Large Sector Size Proposal

To: T13 Technical committee
From: Dan Colegrove
IBM
2903 Carmelo Dr.
Henderson, NV 89052
Phone: 702-614-6119
Fax: 702-614-7955
Email: dcolegro@us.ibm.com
Date: June 10, 2002

Figure <QQ.1> – Unaligned Write Example

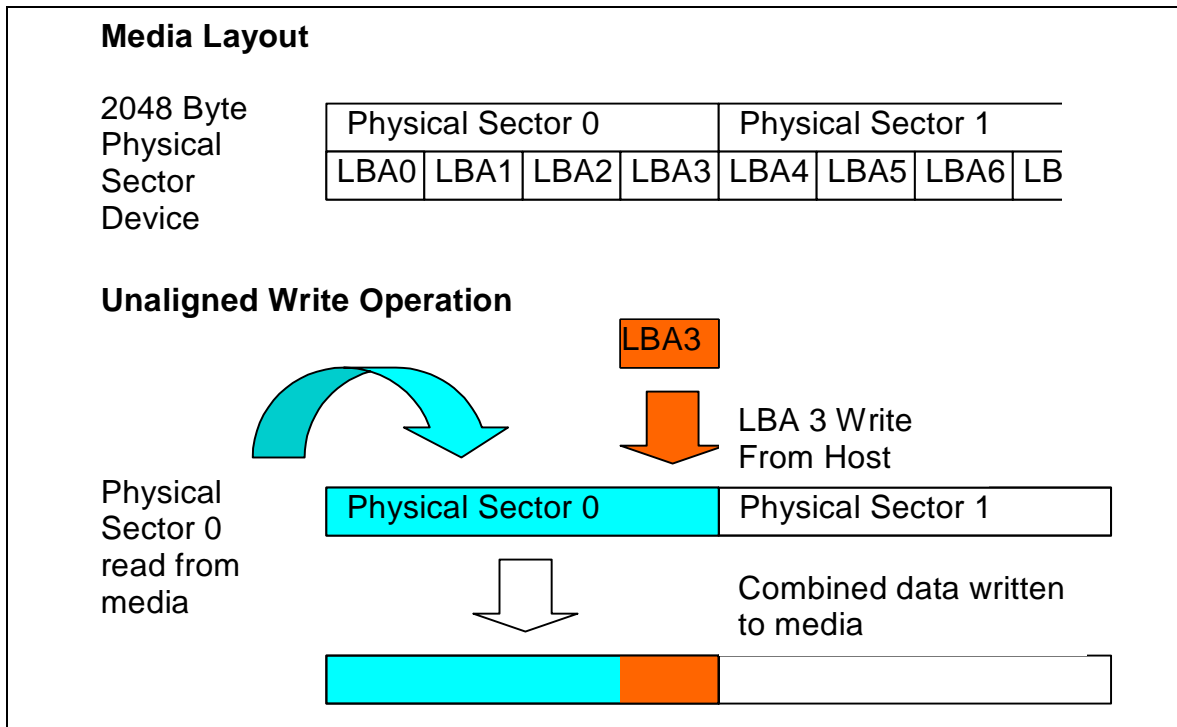
While retaining the 512 byte logical sector maintains software compatibility it introduces a potential performance issue, unaligned write, which must be avoided. A physical sector must be written to the media in a single operation. To complete a write command that writes a fraction of a physical sector the device must read the entire physical sector into buffer memory update the buffer memory with the write data and then write the entire physical sector to the media. This will incur a performance penalty of at least a drive revolution.

Write commands can begin mid physical sector and end mid physical sector resulting in two unaligned writes. In this case the device has to read both the beginning and ending physical sector of the write into the buffer.

Figure QQ.1 illustrates an unaligned write on a device with 2048 byte physical sectors. The First 4 logical sectors, LBA0 – LBA3, reside on physical sector 0. To write only LBA3 the host sends a conventional write command and the data for LBA3. On receipt of the write command the device seeks to the physical sector that contains LBA3, which is physical sector 0. Physical sector 0 is read into the device buffer. Then the new write data for LBA3 is placed in the buffer, overwriting a segment of the buffer. The buffer data is then written to the media, physical sector 0.

To avoid the performance penalty from an unaligned write all write operations must begin with the first sector of a physical sector and end with the last sector of a physical sector.

The first logical sector must begin at the first byte of the first physical sector on the device. This allows a host to align write operations with the physical sectors.
